ADDENDUM NO. 2

BUFFALO AND ERIE COUNTY BOTANICAL GARDENS ADDITION
Erie County DPW Project #2022-903-02
Wendel Project #605802

03-06-2025

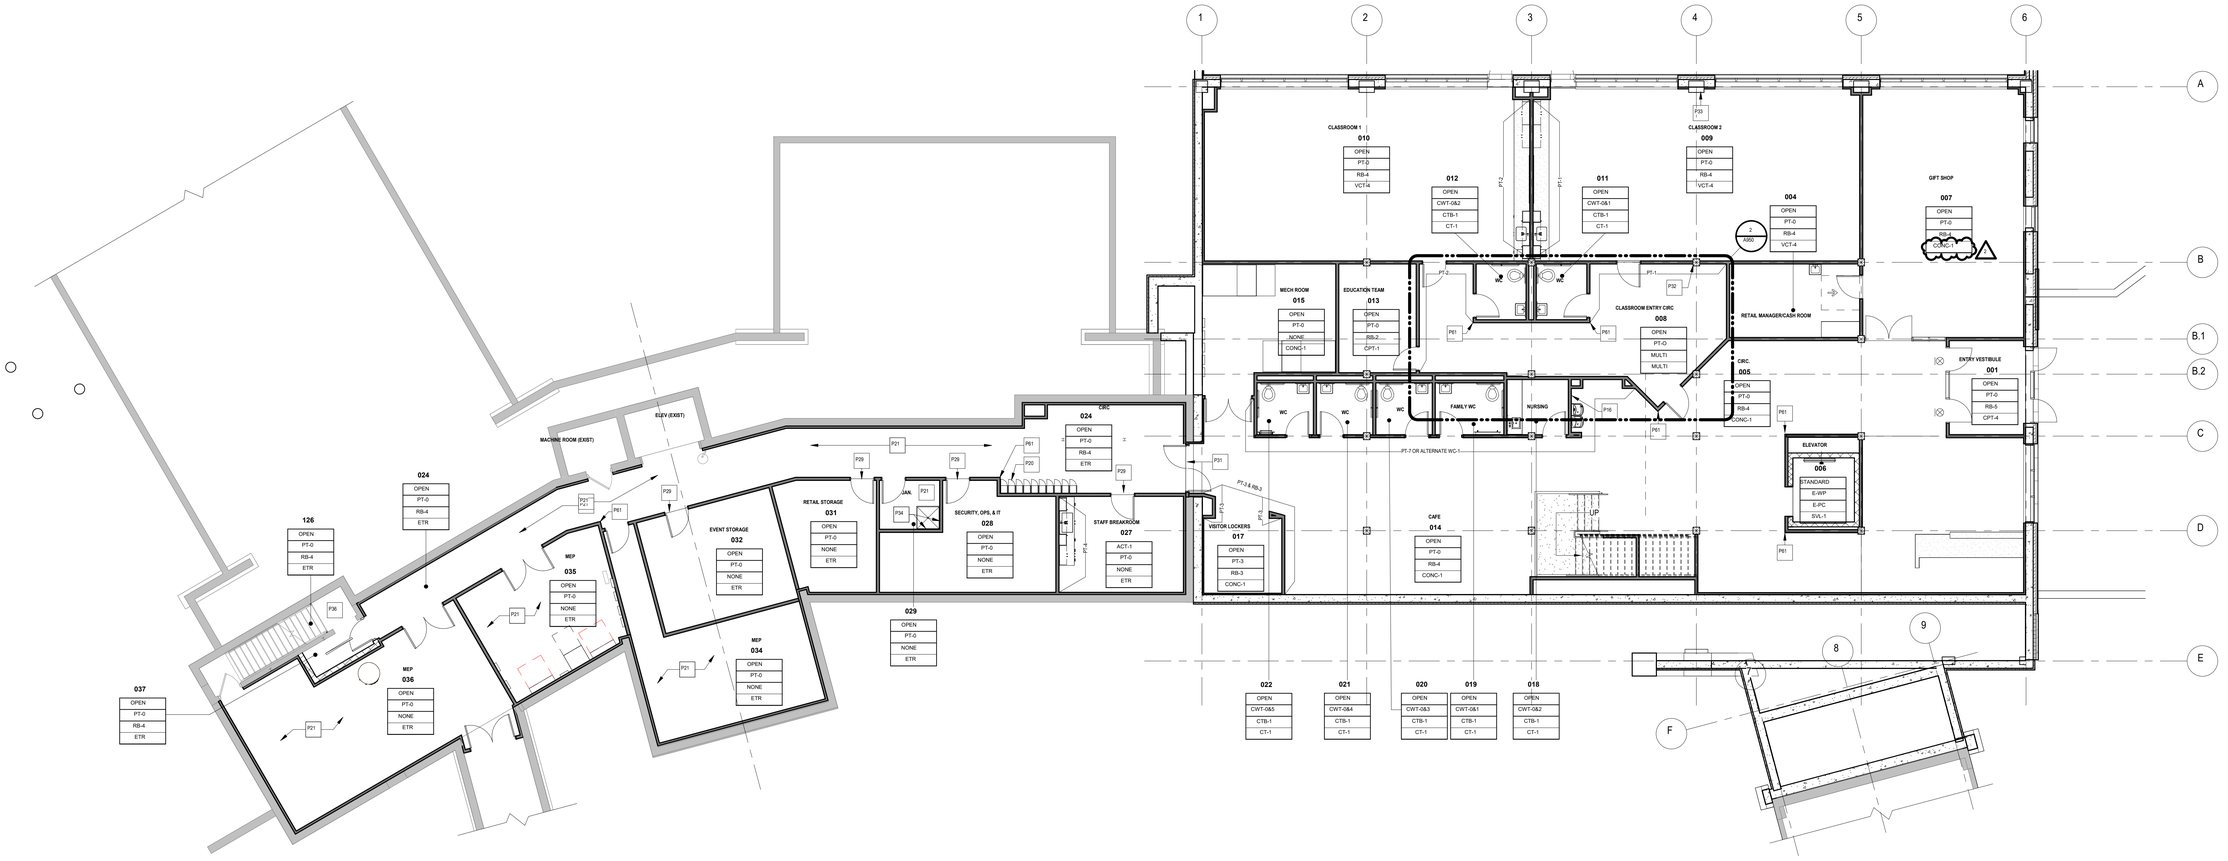
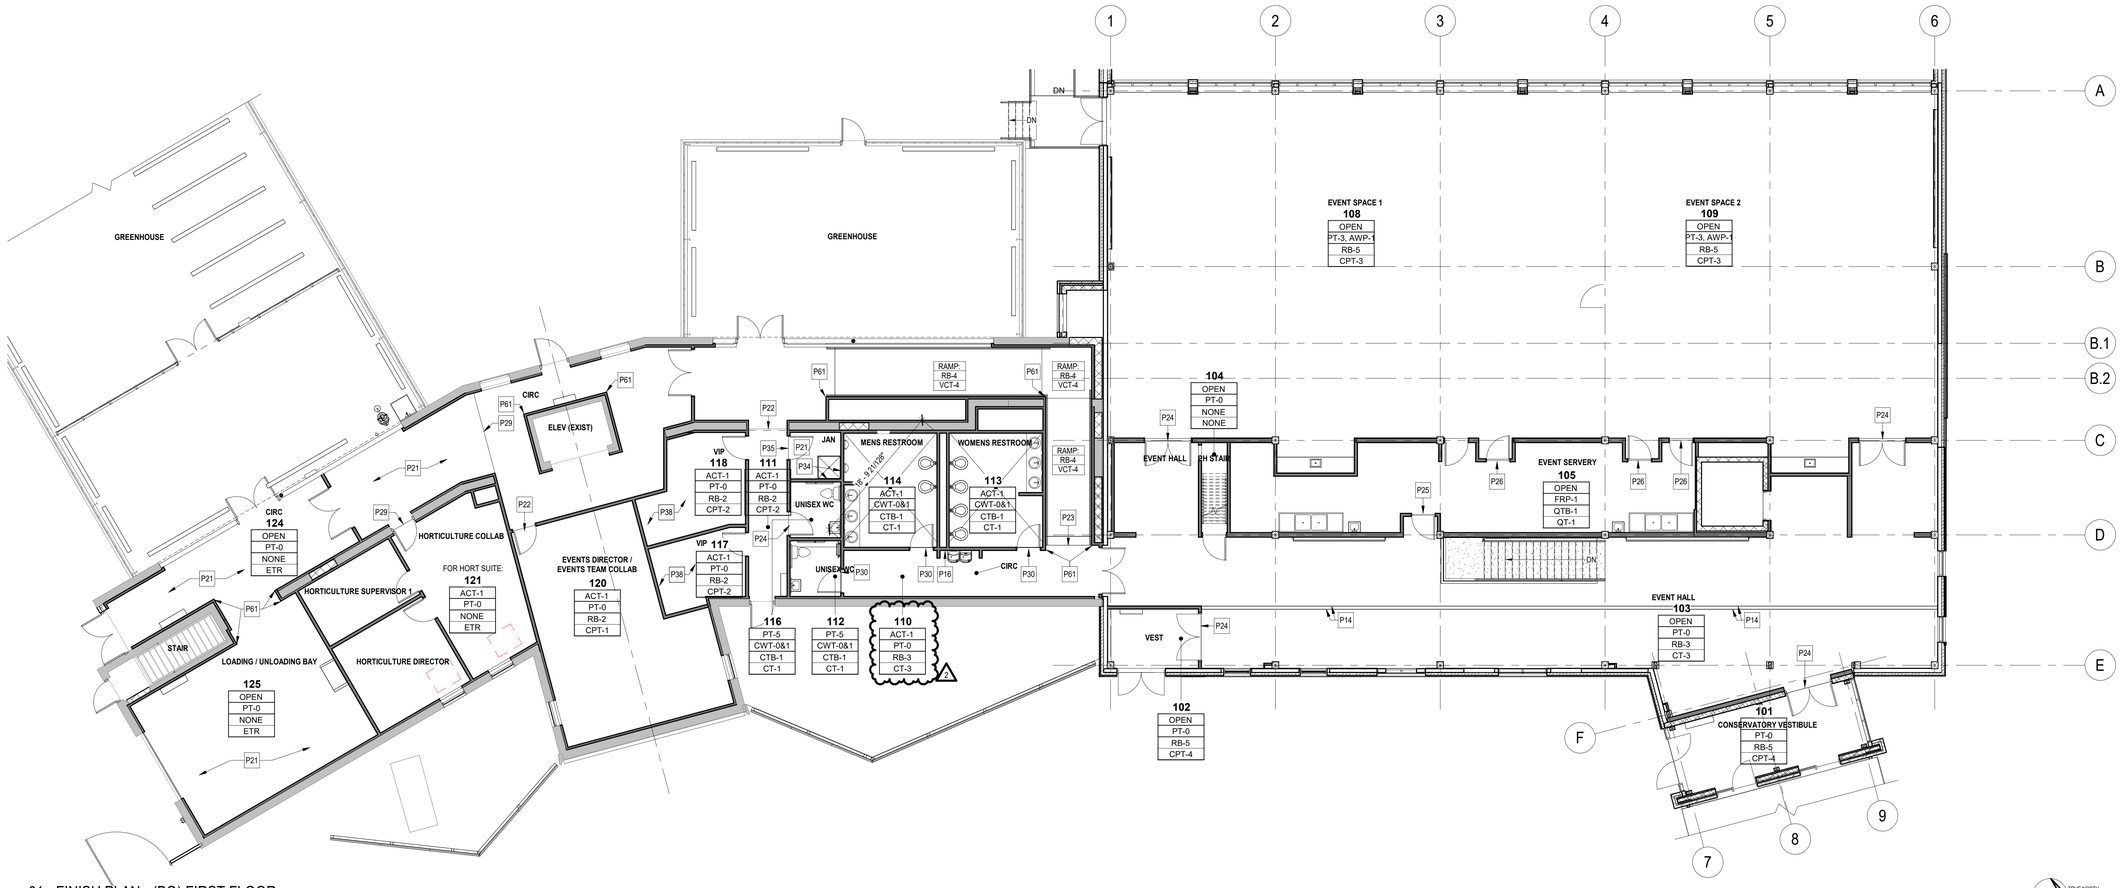
Room finish tag added for Corridor 110 in grow range.

M102

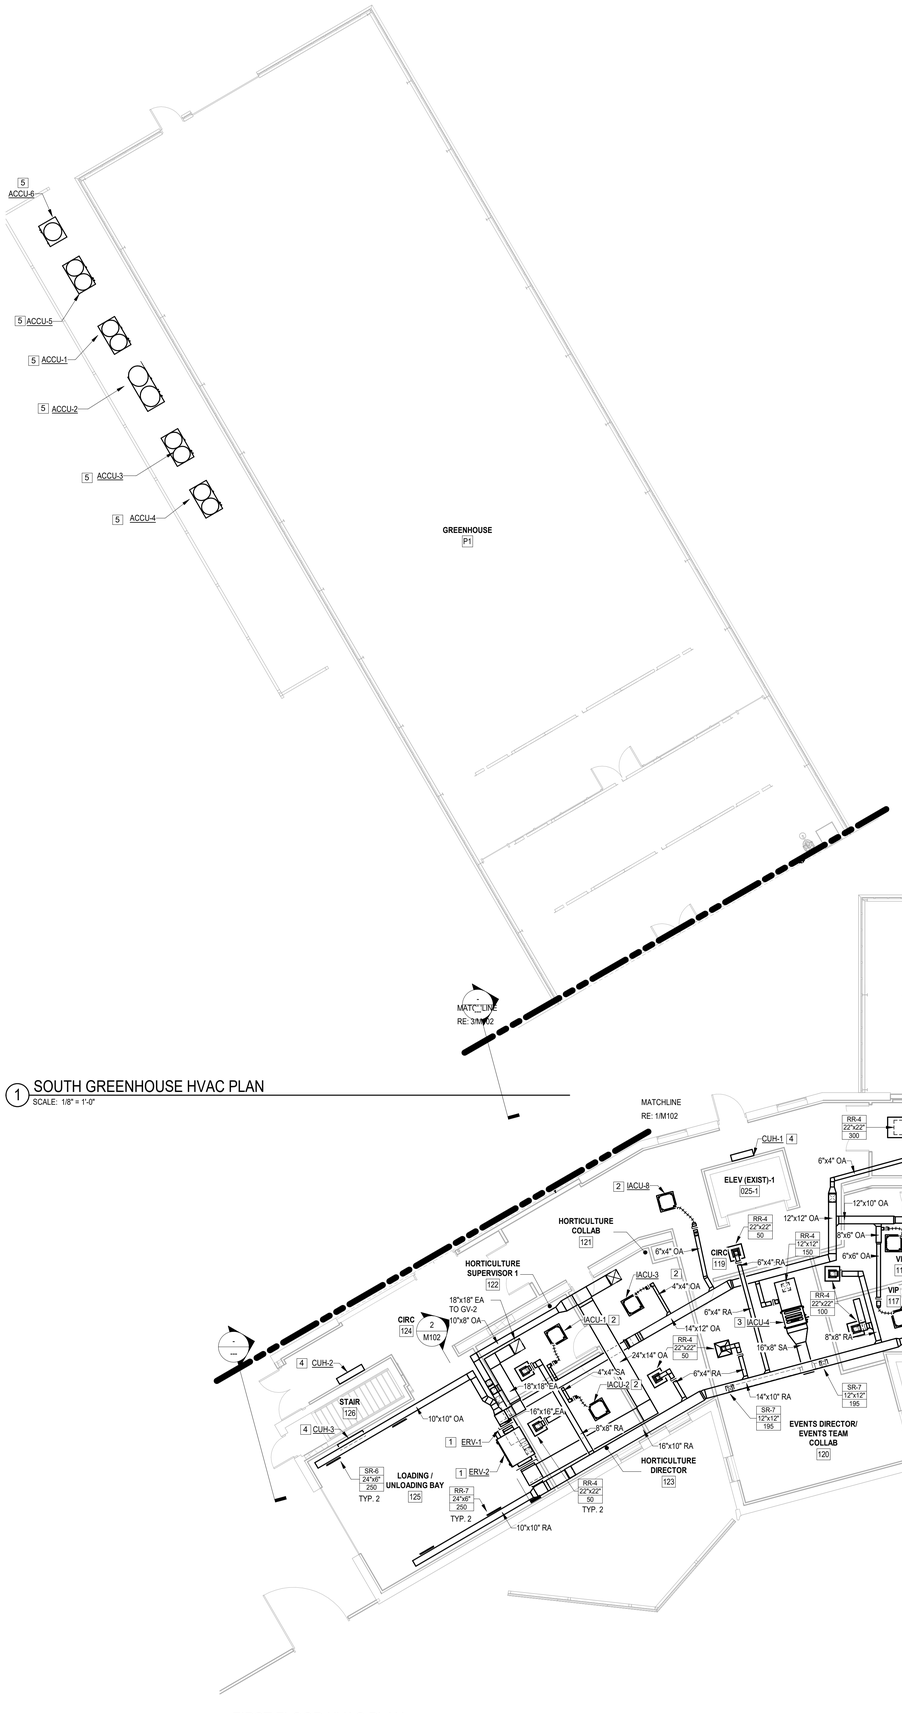
Transfer grille between spaces 103 & 105 relocated to above entry door to space 105. Refer to revised plan.
